File No: LDA13-0212

RE: Tentative plan of subdivision to create 45 single detached residential lot, 58 semi-detached residential lots and one (1) Public Utility lot from SW 3-54-24-4, located east of 82 Street and north of 170A Avenue; **SCHONSEE**

I The Subdivision by Plan is APPROVED on September 5, 2013 subject to the following conditions:

SUBDIVISION CONDITIONS OF APPROVAL MAP

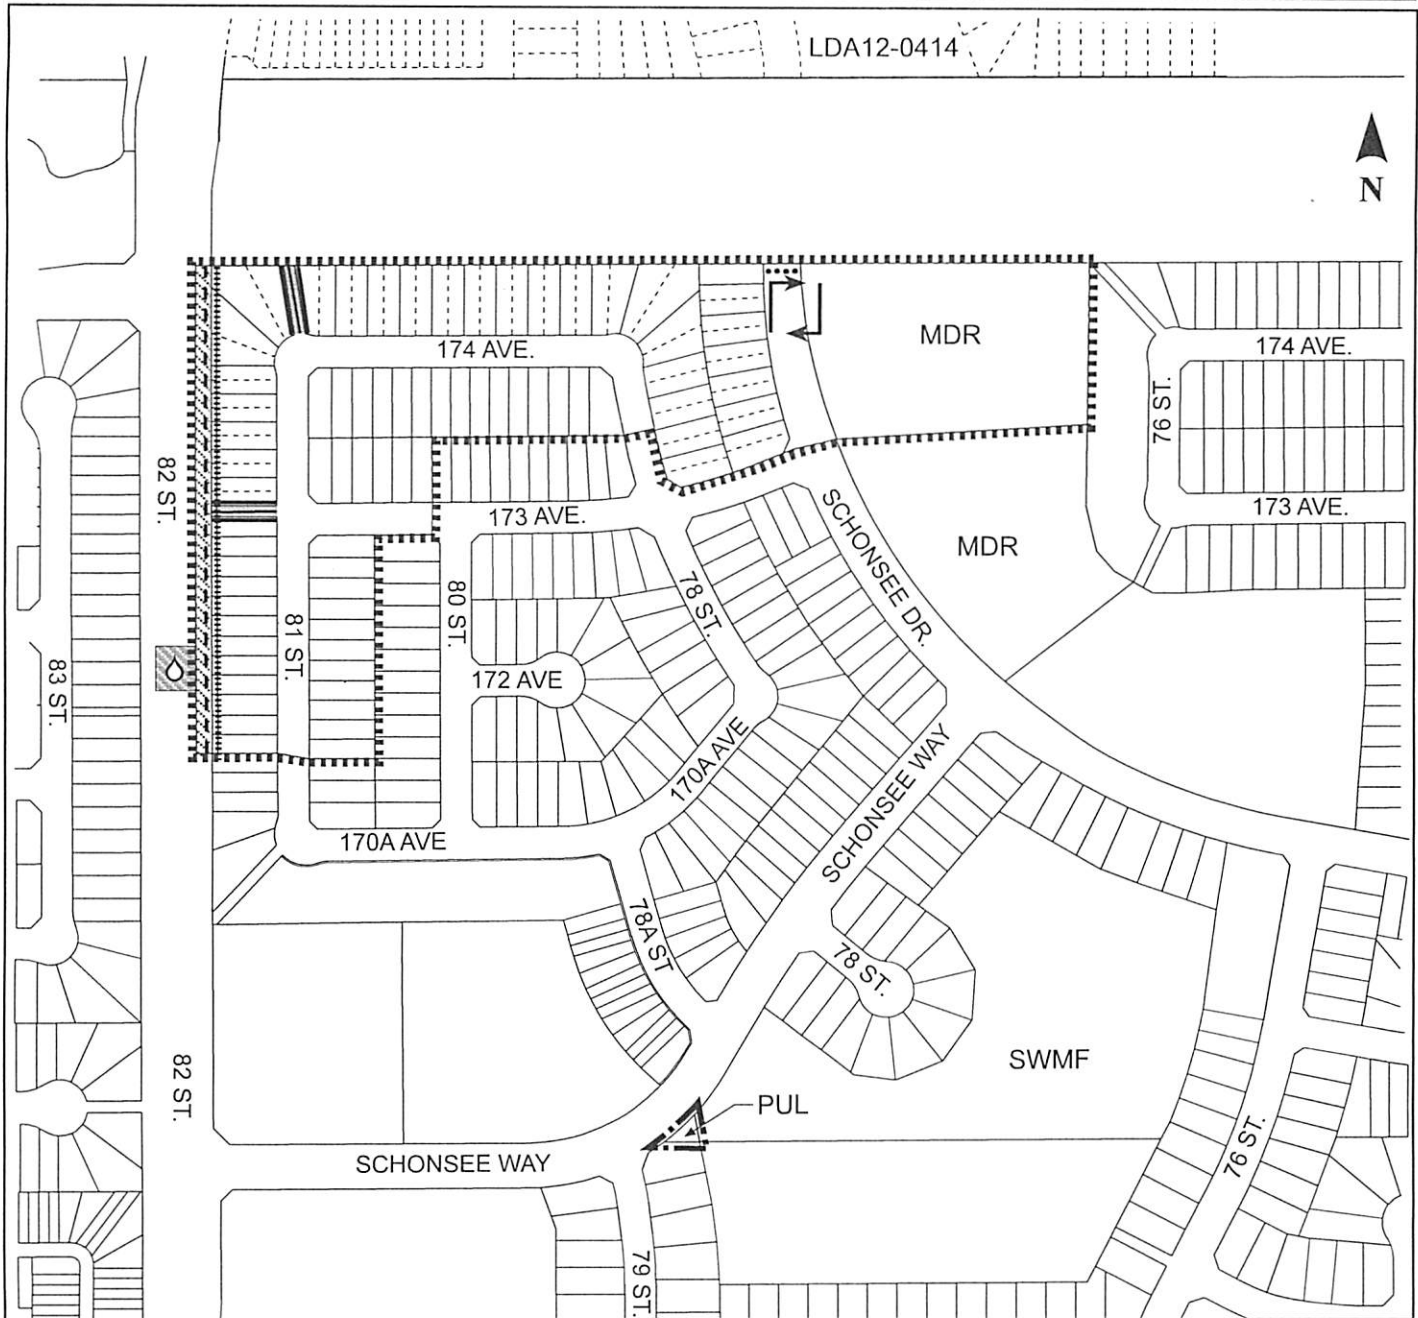
3. that the owner dedicate road right-of-way to conform to an approved Concept Plan, or to the satisfaction of Transportation Services, for 82 Street as shown on the "Conditions of Approval" map, Enclosure I;

4. that the proposed Public Utility lots located in the north and west portion of the proposed subdivision be registered as road right-of-way, as shown on the "Conditions of Approval" map, Enclosure I;

5. that the subdivision boundary be amended to include the dedication of the Public Utility lot adjacent to the stormwater management facility, as shown on the "Conditions of Approval" map, Enclosure I; and

7. that the engineering drawings include the abandonment of the existing 25 mm water service on 82 Street to the satisfaction of EPCOR Water, as shown on the "Conditions of Approval" map, Enclosure I;

8. that the owner construct a 2.5 m shared use path within the 82 Street right-of-way, in the ultimate grade and alignment including "Shared Use" signage, to tie into the existing shared use path located north and south of the subdivision to the satisfaction of Transportation Services, as shown on the "Conditions of Approval" map, Enclosure I;

9. that the owner construct an offset 17 m radius asphalt temporary transit turnaround with bollards, as shown on the "Conditions of Approval" map, Enclosure I. The turnaround will be required at FAC for roads or earlier at the discretion and direction of Transportation Services;

10. that the owner construct 1.5 m concrete sidewalks with bollards, and lighting, as shown on the "Conditions of Approval" map, Enclosure I;
11. that the owner construct a noise attenuation fence as per the City of Edmonton Roadway Design Standards Drawing #5205, within residential property lines, as shown on the "Conditions of Approval" map, Enclosure I;

12. that the owner construct all fences positioned wholly on privately-owned lands to the satisfaction of Sustainable Development in the location as shown on the "Conditions of Approval" map, Enclosure I; and
